**Re:** 23 Howe Rd Special Permit # 129-16

# Consistency Ruling (#129-16) - 23 Howe Road

Severini Residence

# Approved Plans per #129-16

Foundation  
& First Floor Plans

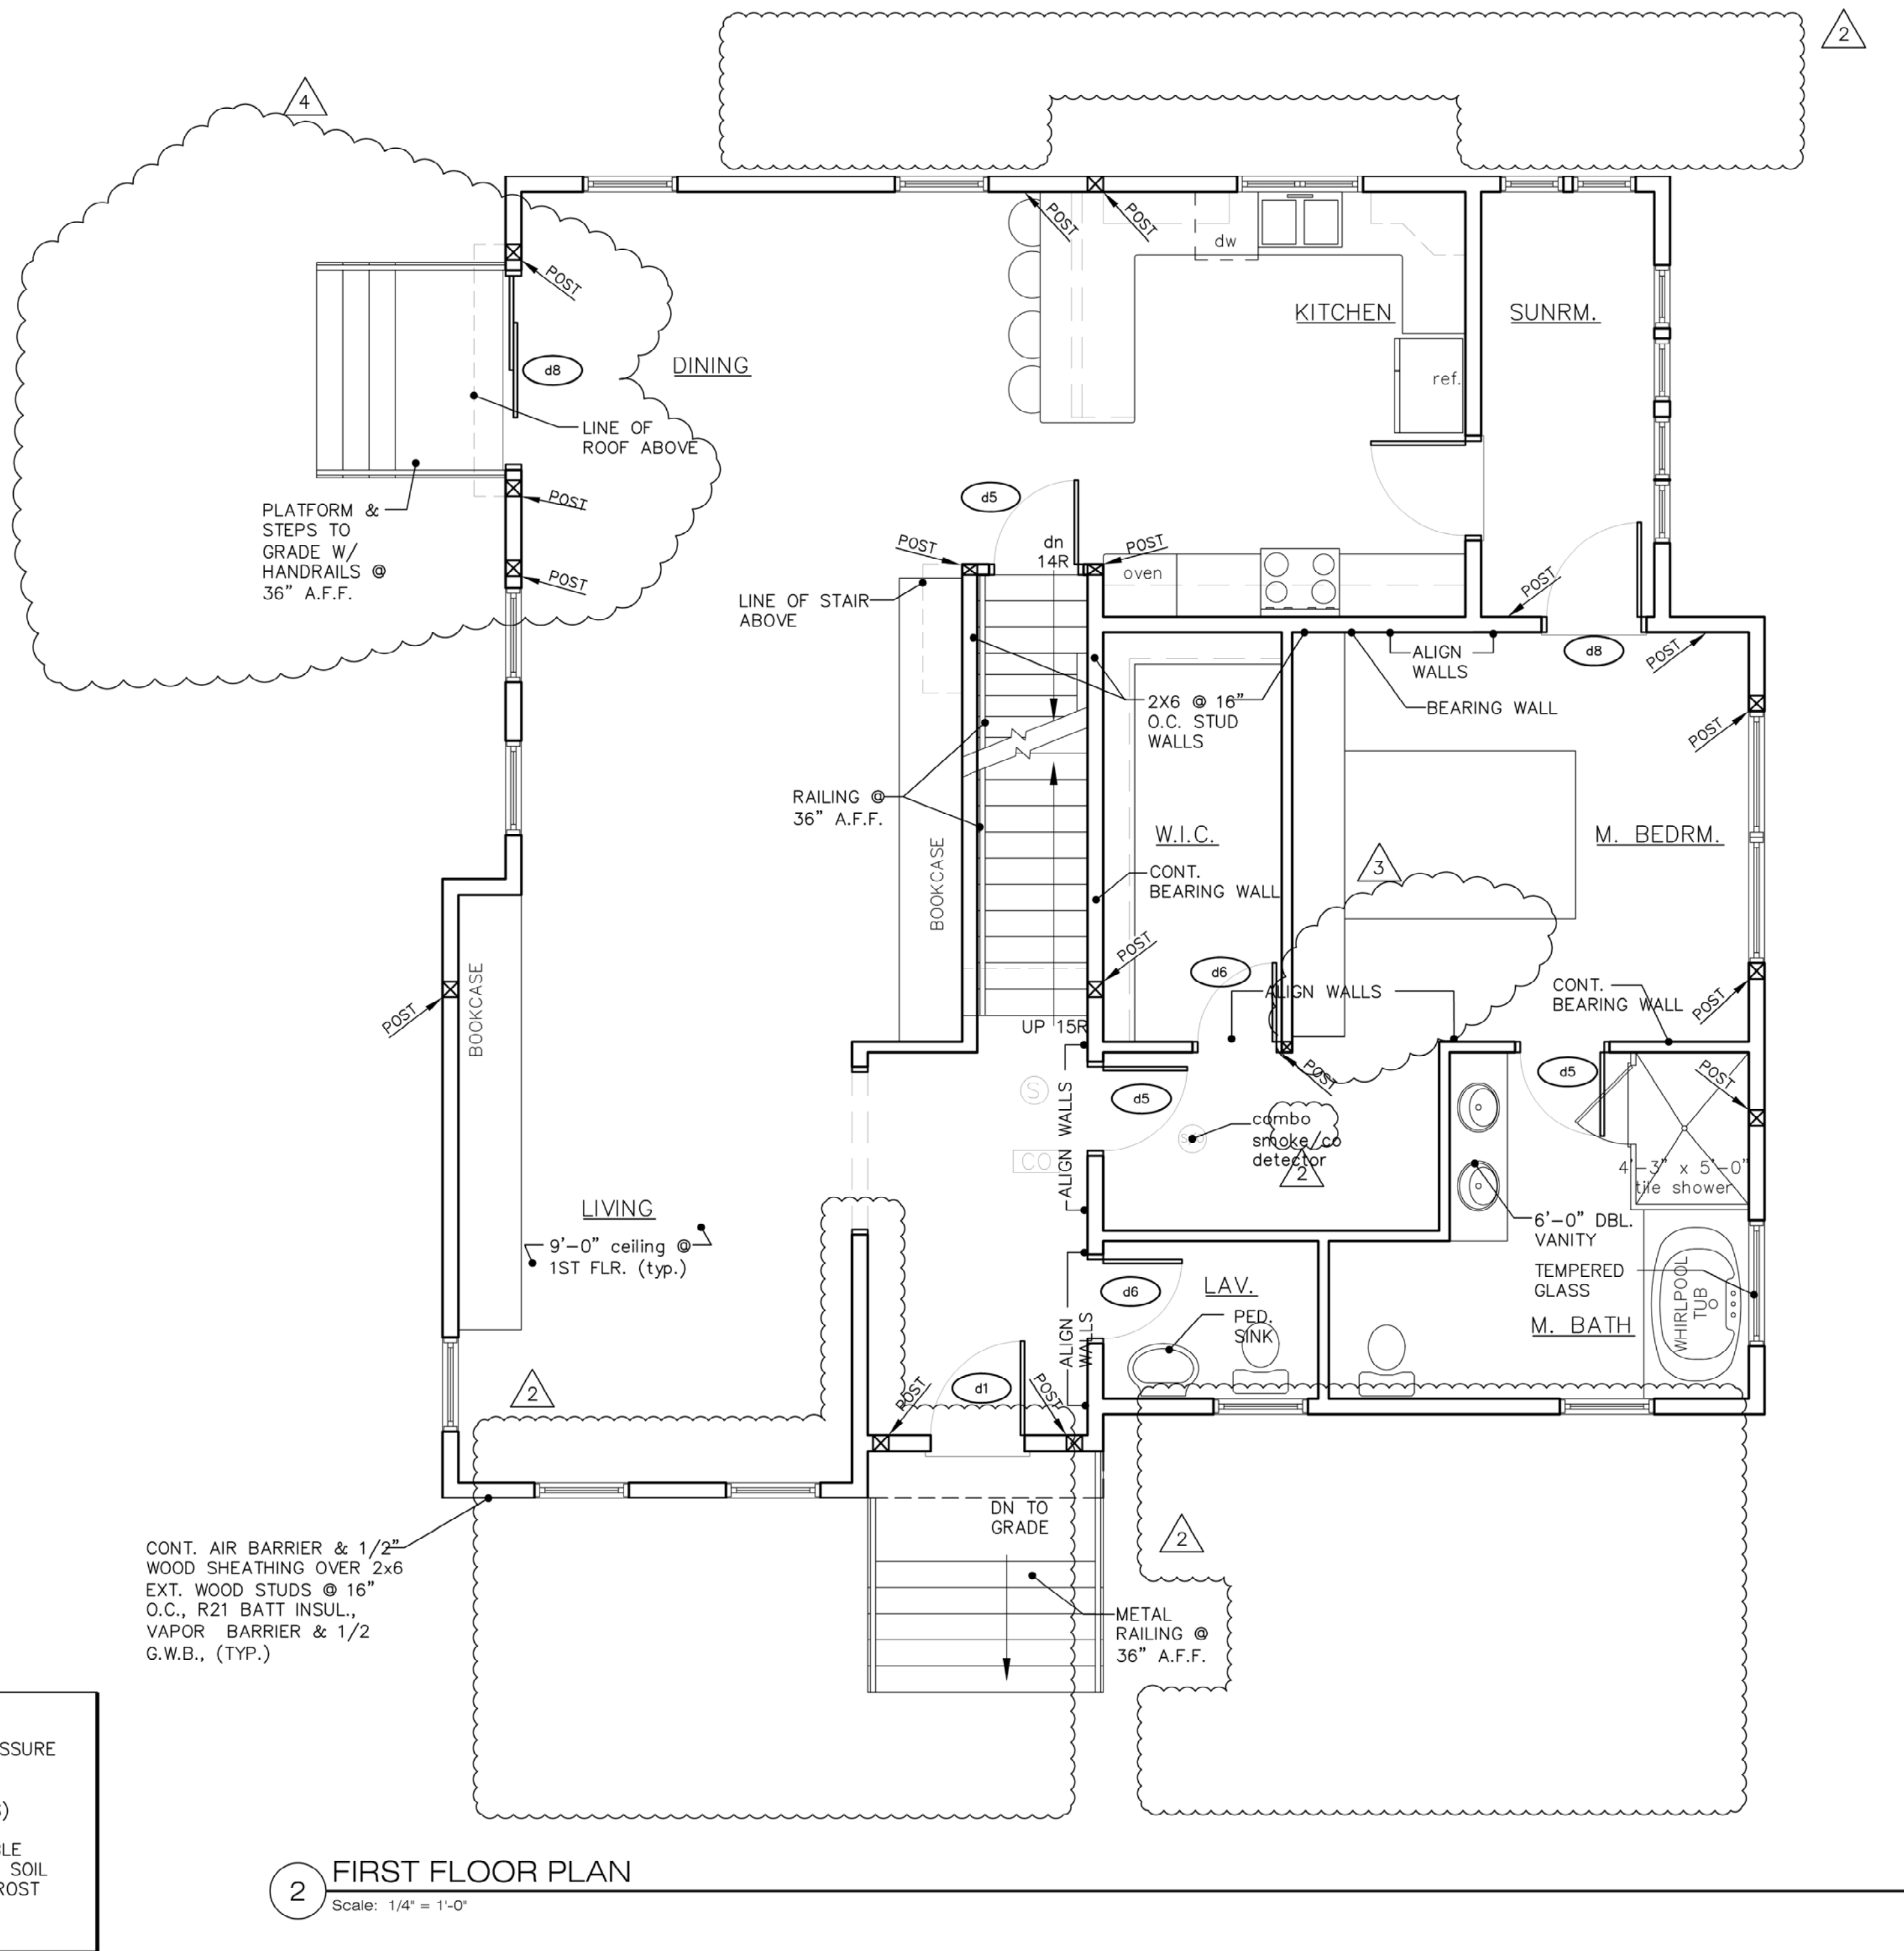
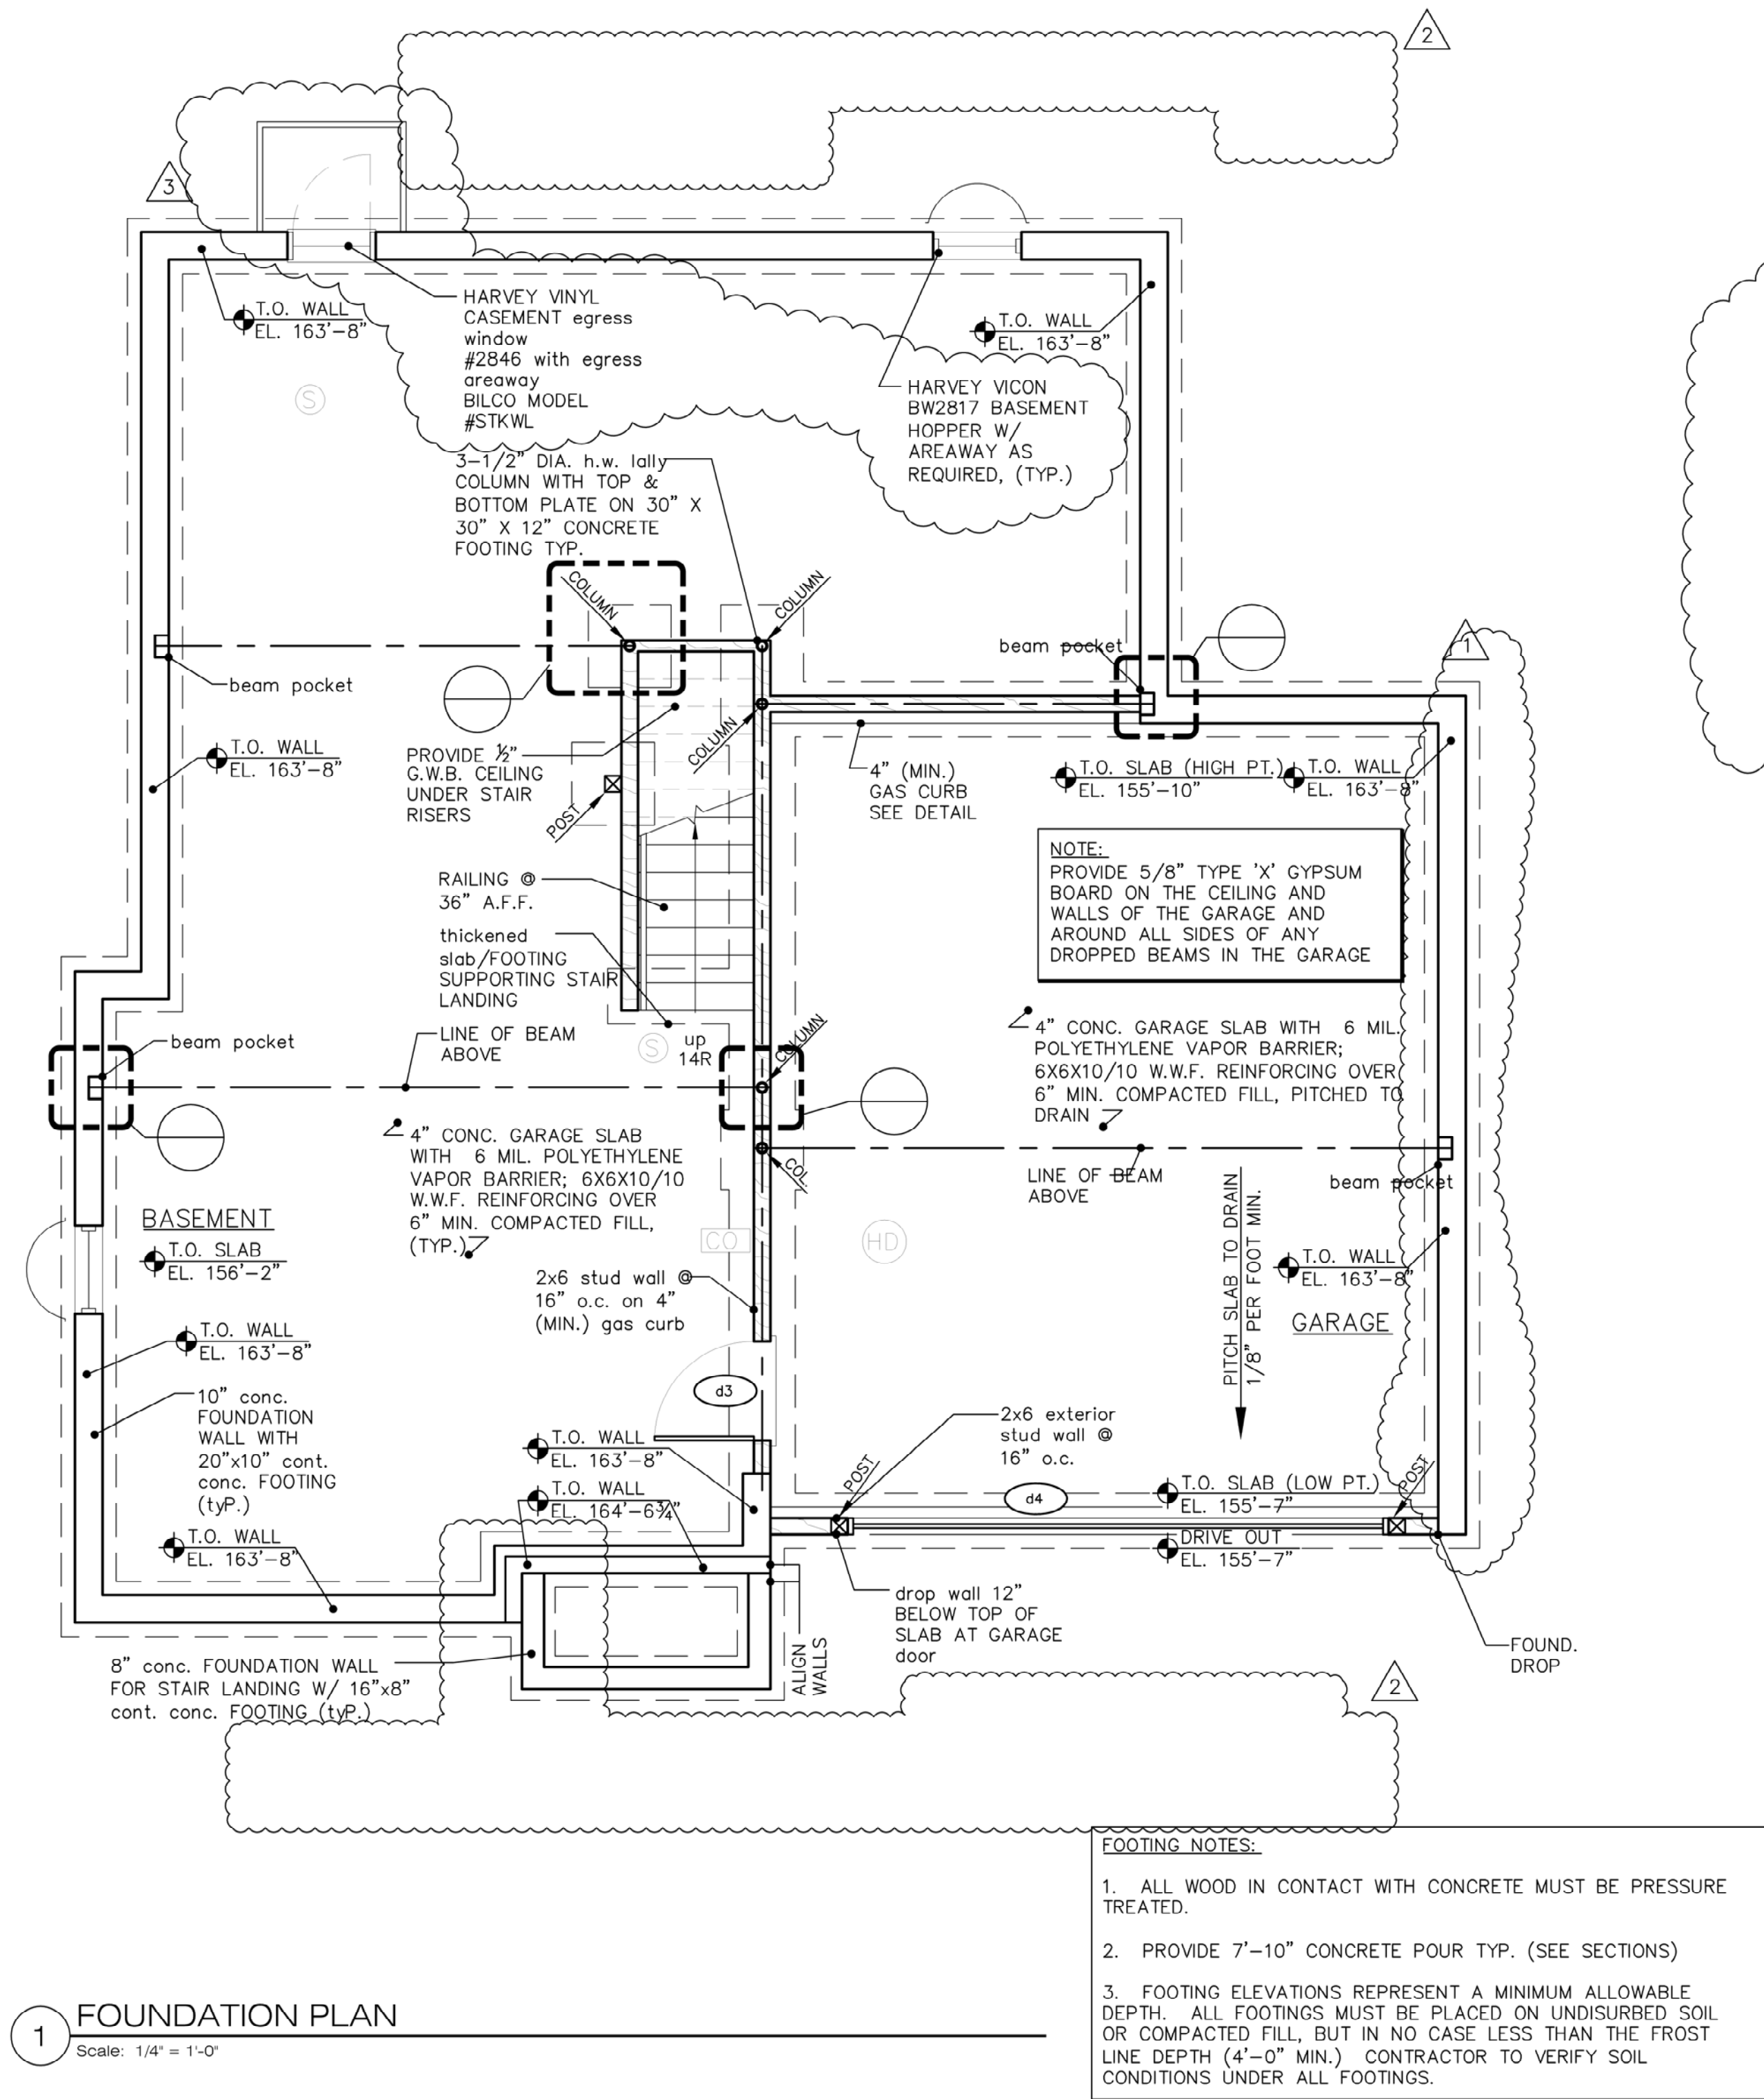
These revisions actually simplify the rooflines, remove all the dormers and any living space on the third floor. We used some of that square footage to add a small sunroom in place of a larger patio to the first and raise the roof over the kitchen, eliminating the kitchen volume ceiling in favor of adding living space in that area. The lot setbacks and height of the main ridge are unchanged. We reviewed the FAR chart and method for square footage with Anthony Ciccariello to make sure we were counting the areas properly.
